MERIDIAN STORAGE

GRADING & EROSION CONTROL PLANS

VR239 & SDP2336

Additional comments on the GEC Plan may be necessary and provided based on review of the final plat and construction drawing.

INITIAL EROSION CONTROL PLAN

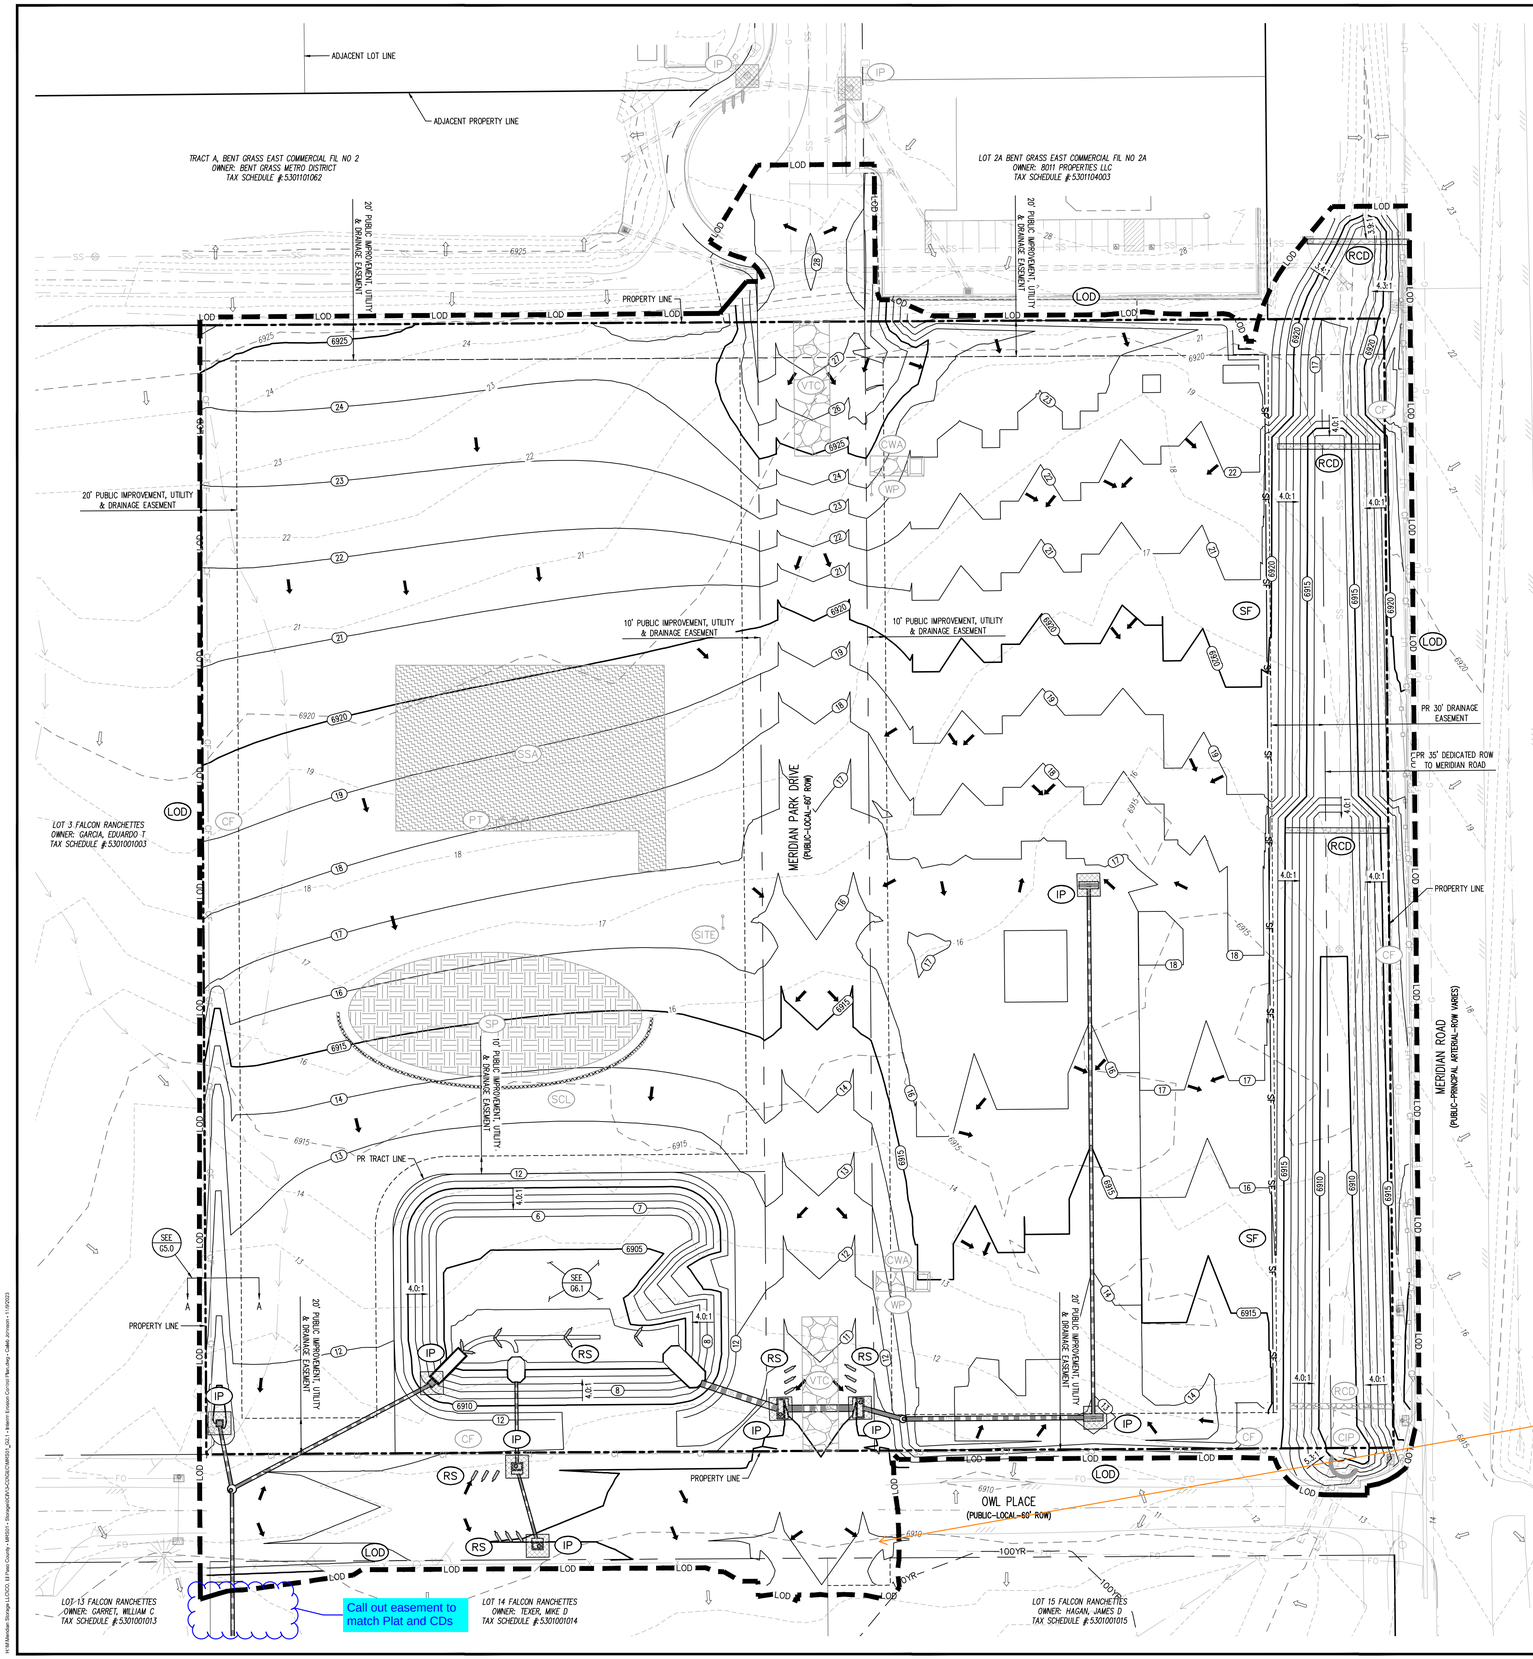
Unresolved from Submittal 1 - GEC Checklist Item o:
Clearly label off-site grading.
GEC Checklist Item cc: Label proposed off-site easements.
Show preliminary/tentative easement linework if easements have not been acquired yet.

VTC-1. AGGREGATE VEHICLE TRACKING CONTROL

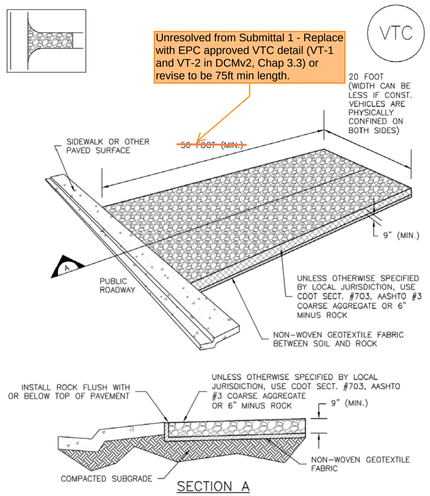
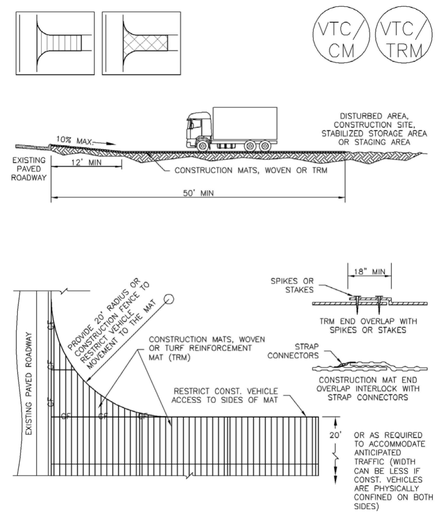
Unresolved from Submittal 1 - Replace with EPC approved VTC detail (VT-1 and VT-2 in DCMv2, Chap 3.3) or revise to be 75ft min length.

OUTLET CONTROL STRUCTURE – PLAN DETAIL

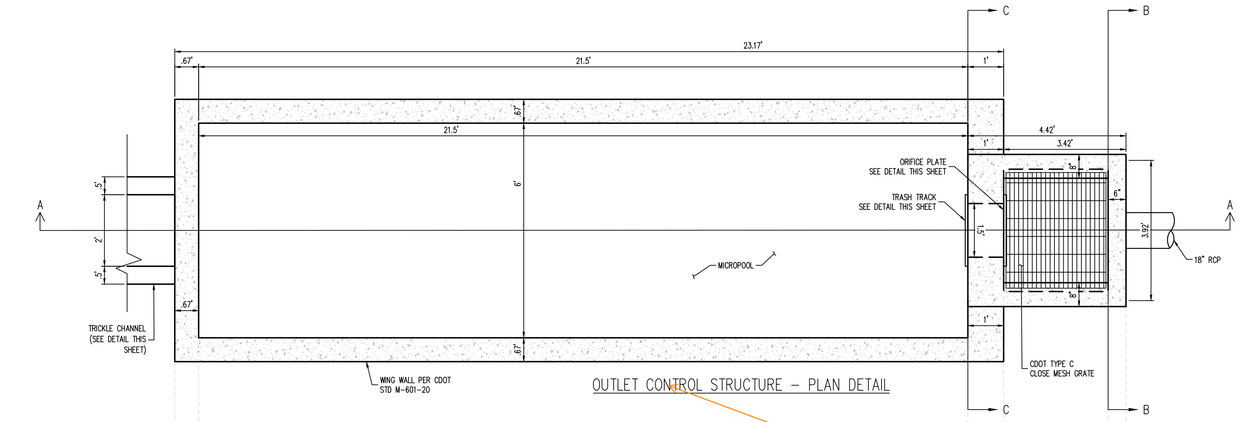
Show safety rail in plan view

OUTLET CONTROL STRUCTURE – SECTION A–A

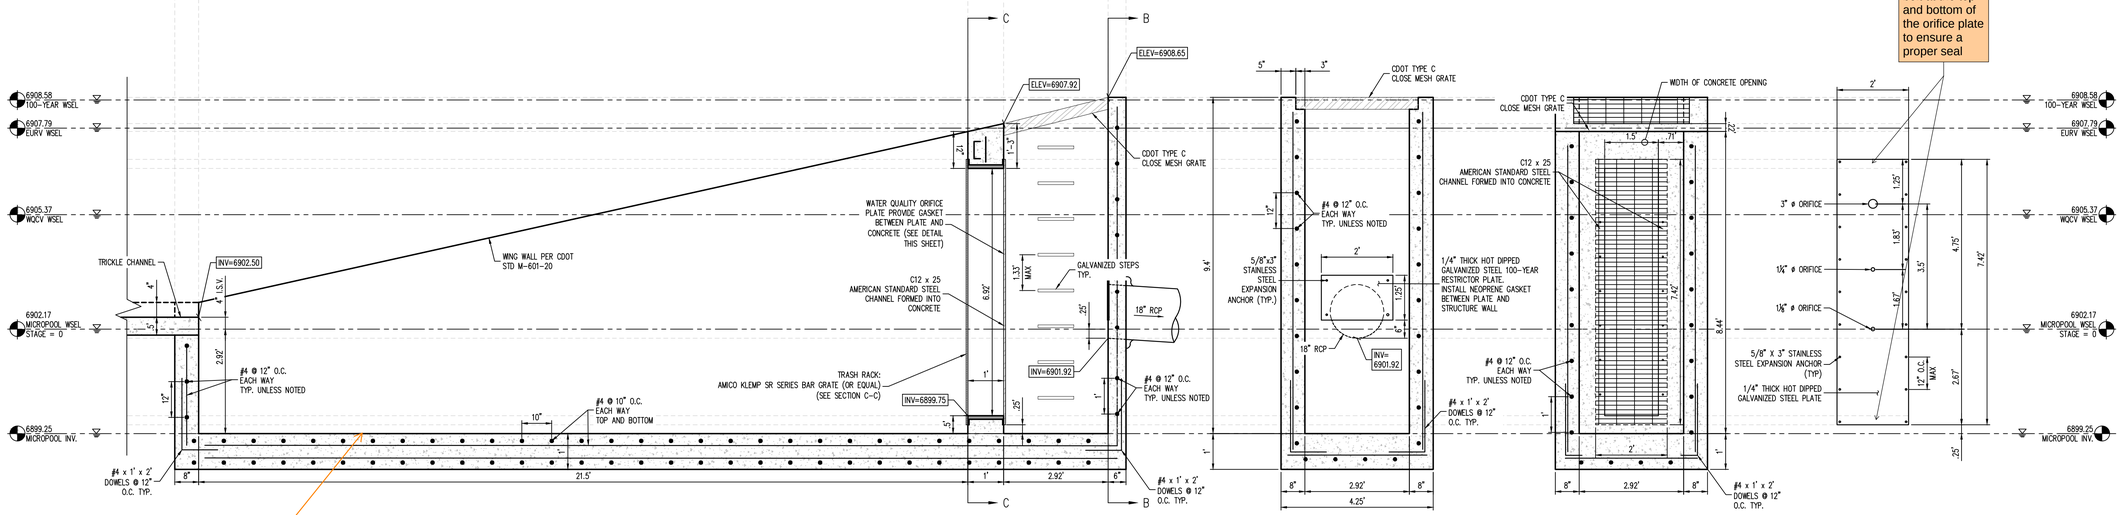
Unresolved from Submittal 1 - include a bolt at the top and bottom of the orifice plate to ensure a proper seal
